COUNCIL SUPPLEMENTARY ASSESSMENT REPORT

Panel Reference	PPSSHH-98
DA Number	LDA2020/169
LGA	City of Ryde
Proposed Development	Construction of an eleven (11) storey commercial and retail building comprising excavation for two (2) levels of basement car park for 246 car parking spaces, four (4) ground floor retail tenancies, ten (10) levels of commercial tenancies, plant areas and solar panels on the roof level, end of trip facilities including 236 bicycle spaces, lockers and amenities, landscaping and public domain upgrade works along Waterloo Road.
Street Address	45-61 Waterloo Road, Macquarie Park
Applicant/Owner	John Holland Macquarie Park Land Custodians Pty Ltd
Date of DA lodgement	20 May 2020
Date of previous SNPP Meeting	30 June 2021
Recommendation	Approval
List all documents submitted with this report for the Panel's consideration	Attachment 1: Previous report to the Sydney North Planning Panel for the meeting dated 30 June 2021 Attachment 2: Revised draft conditions of consent

Report prepared by	Sandra Bailey, Manager Development Assessment
Report date	22 July 2021

Figure 1. Overlay of the temporary road over the basement plan. Red dashed line indicates temporary sheet pile shoring wall. Yellow squares indicate main building. Source: Staged Construction Management Report prepared by EI Australia dated 15th July 2021.

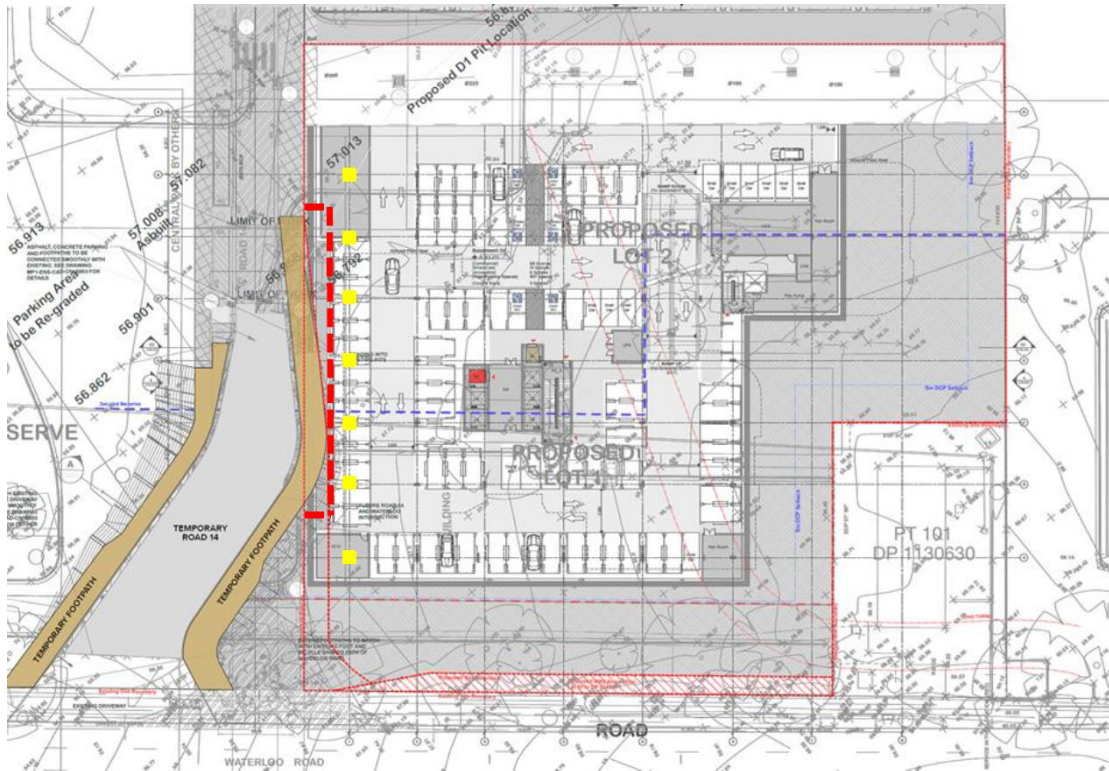
Figure 1 demonstrates the location of the easement and the area of work that is to be excluded from Stage 1. This is further detailed in Figure 2. It is proposed to provide temporary shoring adjacent to the area to be excluded from Stage 1. The temporary shoring would not be removed until Stage 2 of the development which will only occur once the easement has been extinguished.

Figure 2. Area of basement shoring Stage 1 and Stage 2 works. Source: Staged Construction Management Report prepared by EI Australia dated 15th July 2021.

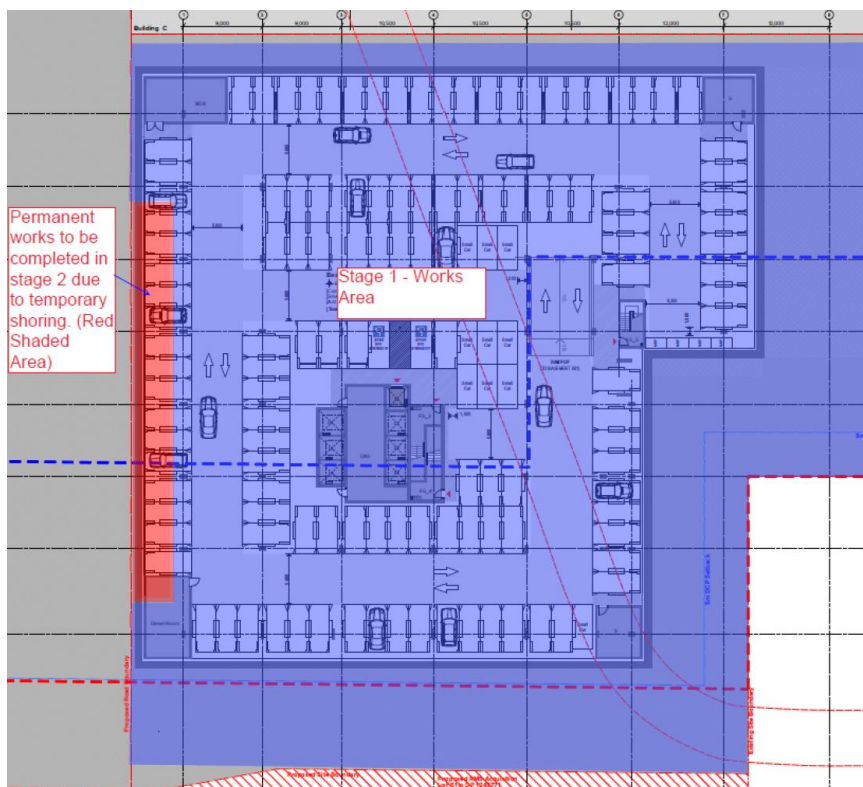
The condition should also be amended to provide greater certainty that excavation is not to occur within the easement during Stage 1 and that prior to a CC for Stage 2, written confirmation should be provided from Council to the Certifier to confirm the easement has been extinguished.

- Construction of the development is to be staged in accordance with the Staged Construction Management Plan (SCMP) prepared by EI Australia, dated 15 July 2021. Stage 1 does not permit any construction or excavation within the area marked in red on Figure 2 of the SCMP. Prior to the issue of a Construction Certificate for the works within Stage 2 as described in the SCMP, written evidence must be provided from Council to the Certifier that easement (K) that benefits Lot 4 DP1255496 and burdens Lot 1 DP1231416 and Lot 2 DP1255496 has been extinguished. For clarity purposes it is noted that works within Stage 1 can occur whilst easement (K) is in place.
- During Stage 1 of the development, safe and accessible pedestrian access must be provided at all times over easement (K) that benefits Lot 4 DP1255496 and burdens Lot 1 DP1231416 and Lot 2 DP1255496.

- The temporary shoring required to be provided in the basement levels must be certified and maintained in accordance with the National Construction Code requirements throughout the course of its life.
